Item # 5
MCPB
10/17/02

MEMORANDUM

REVIEW TYPE: Site Plan Review
APPLYING FOR: Approval of 78,300 square feet office and 11,700 square feet day care use on 5.88 acres
PROJECT NAME: Germantown Business Park, Qiagen
CASE #: 8-98022B
REVIEW BASIS: Sec. 59-D-3, M. C. Zoning Ordinance

NEW PARKING GARAGE (SECTION A-A)

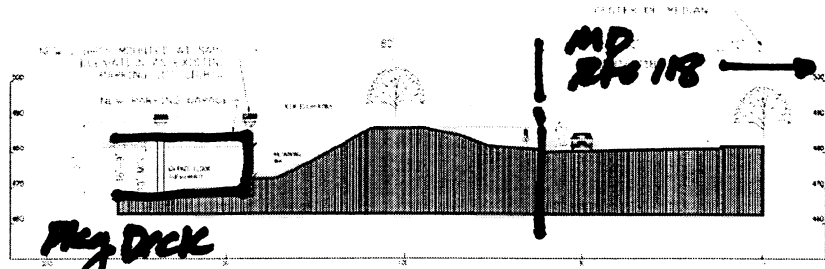
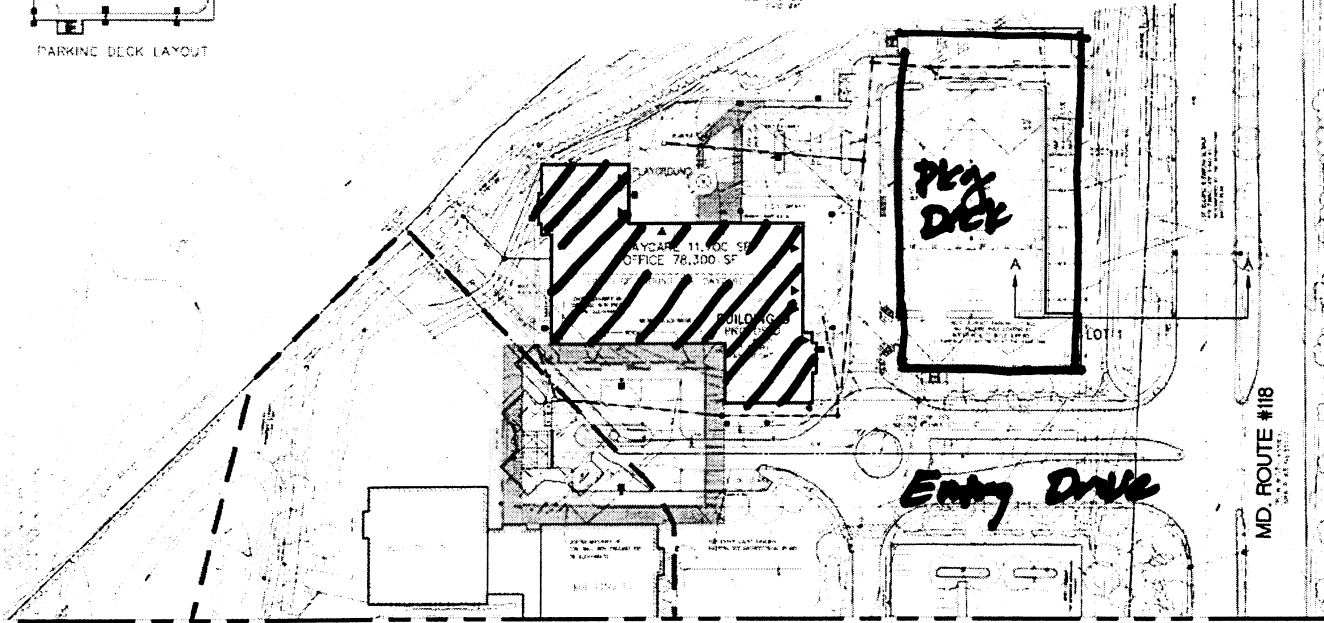
The first level of the office building will house 11,700 square feet of day care center and the remainder shall be 78,300 square feet of administrative offices for Qiagen. Qiagen shall occupy the remaining two floors. A two level parking garage will be located to the south along the MD Route 118 frontage, in a similar fashion to the parking garage previously approved for Phase I and II. The upper level of the parking garage is level with the road surface of MD Route 118. An earthen berm divides the parking garage from MD Route 118 and is 6 feet taller than the parking garage. The berm will be landscaped with evergreen plant materials as well.

Lighting proposed for the site provides light for all areas of the site. At this time, the poles, light fixtures and light levels differ from the Phase I site plan. In order to maintain continuity within the site, staff recommends that the light design be revised to reflect the earlier approvals within Site Plan #8-98022A. This would include the similar wattage, style of light, house shields on the street side of the parking deck and the resultant footcandle distribution should be the same.

1. The final Lighting Plan shall replicate the light levels, fixtures and house shields as shown on approved Site Plan #8-98022A for the top of the garage deck and elsewhere on site. Light fixtures to be revised on both site plans to include a fixture where the bulb (or lamp) is hidden.
